MODEL 165 RX

CYLINDER COVER

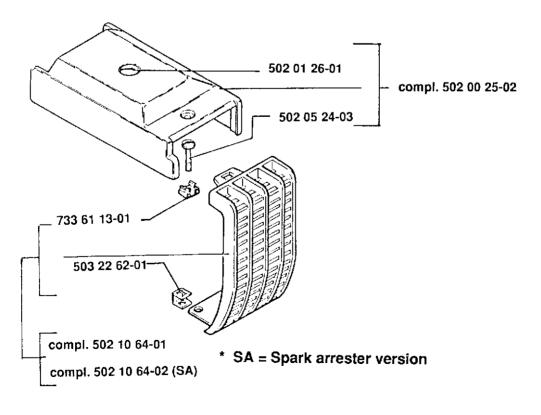
In order to even more improve the cylinder cover attachment, a screw and nut are introduced between the cylinder cover and the heat shield.

This means the following new parts:

<u>New Ref. No.</u>	Description	<u>Exclude d Ref. N</u> o.
502 05 24-03 733 61 13-01	Screw Special nut

NOTE! Ref. No. 502 00 25-02 Cylinder cover compl., Ref. No. 502 10 64-01 Heat shield compl, and Ref. No. 502 10 64-02 Heat shield compl. (SA*) Remain unchanged and are fully interchangeable with the previous design.

The screw 502 05 24-03 is excluded, when mounting a new cylinder cover with previous design of heat shield.
